Item Name: Fwd Crosstube - Mid Height 206L / L1 / L3 / L4, Blue

DART AEROSPACE LTD		Work Order:	164169
Description: Crosstube Mid Fwd (206L)		Part Number:	D206-667-107
Inspection Dwg: D206-667-147 Rev: A		Page 1 of 1

DART AEROSPACE LTD HAWKESBURY, ONTARIO, CANADA	
DRAWING NO. D206-667-147	REV. A SHEET 1 OF 4
TITLE CROSSTUBE ASS'Y (206L MID FWD)	SCALE NTS
COPYRIGHT © 2010 BY DART AEROSPACE LTD THIS DOCUMENT IS PRIVATE AND CONFIDENTIAL, AND IS SUPPLIED ON THE EXPRESS CONDITION THAT IT IS NOT TO BE USED FOR ANY PURPOSE OR COMMUNICATED TO ANY OTHER PERSON WITHOUT WRITTEN PERMISSION FROM DART AEROSPACE LTD.

DRAWING NO. D206-667-147	TITLE CROSSTUBE ASS'Y (206L MID FWD)	REV. A	DART AEROSPACE LTD ENGINEERING ORDER		D.E.O. NO. D206-667-147-A-1	SHEET NO. SHEET 1 OF 1	SCALE NTS
DRAWN <i>qp</i>	CHECKED <i>ADS</i>	MFG. APPR. <i>JS</i>	APPROVED <i>MD</i>		DE APPR. <i>MD</i>		
DATE 11.07.15	DATE 11.07.20	DATE 11.07.21	DATE 11.07.21		DATE 11.07.21

DETAIL P
BONDING STRAP INSTALLATION 2 PL

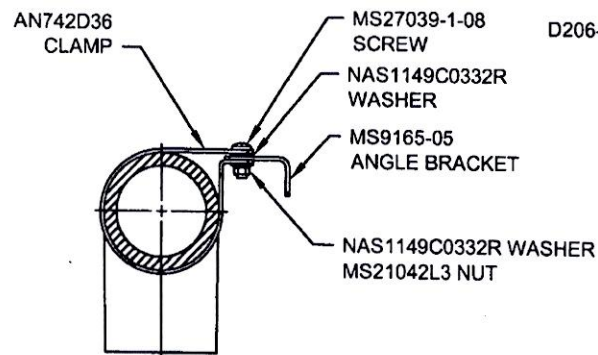
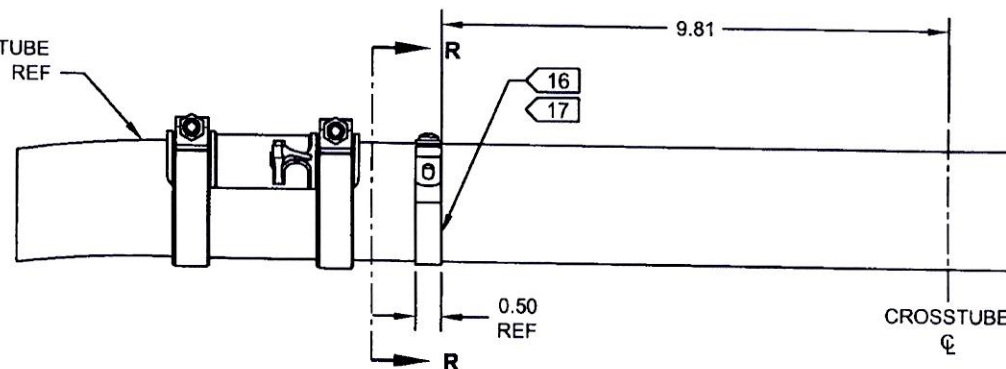
ADD ELECTRICAL GROUNDING STRAP

- 16) MASK AREA UNDER CLAMP PRIOR TO PAINTING
- 17) SEAL EDGES WHERE AN742D36 CLAMP MEETS WITH THE CROSSTUBE USING SIKAFLEX-241/-291 OR MIL-S-8802 CLASS B2 OR PROSEAL 890 SEALANT
- 18) PERFORM RESISTANCE CHECK TO ENSURE MAX RESISTANCE IS 10 MILLIOHMS

ITEM	QTY -147	PART NUMBER	DESCRIPTION
1	X	D206-667-147	CROSSTUBE ASSEMBLY (206L MID FWD)
10	2	AN742D36	CLAMP
11	2	MS9165-05	ANGLE BRACKET
12	2	MS21042L3	NUT (OR MS21042-3)
13	2	MS27039-1-08	SCREW
14	4	NAS1149C0332R	WASHER (OR AN960C10L)
